January 31, 2023

ADDENDUM NO. 3

**FAITHON P. LUCAS BOULEVARD
PAVING AND DRAINAGE RECONSTRUCTION
(MCKENZIE ROAD TO E. CARTWRIGHT ROAD)
RFP NO. 2023-029**

COMBINATION RAIL TEXAS CLASSIC

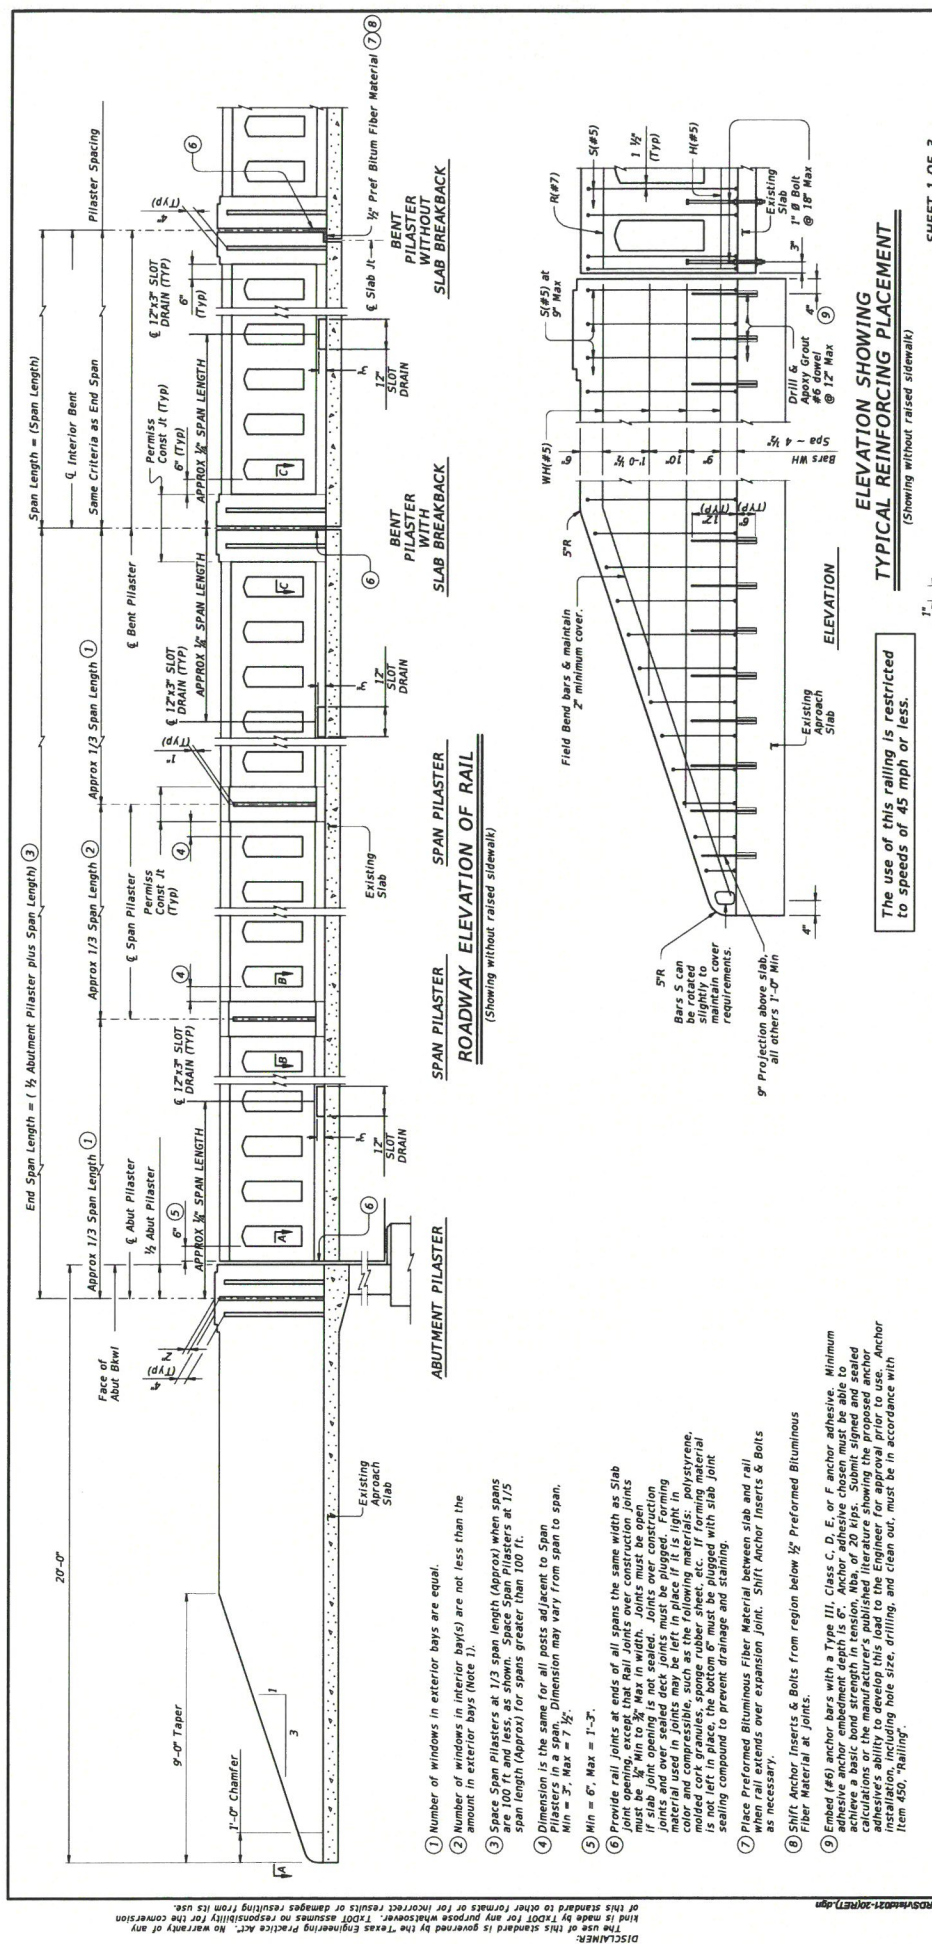
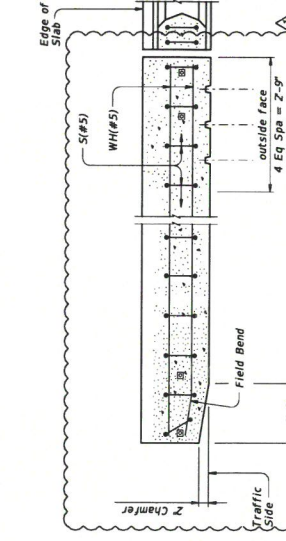
Question 53 Follow-up to question #10 - Plan Sheet 233 "Combination Rail Texas Classic Type C411(MOD) which window type A, B or C is to be used on the project?

REV. NO.	DATE	DESCRIPTION	BY
1	1-27-23	MODIFIED RAIL	TFT

Response: Type A window.
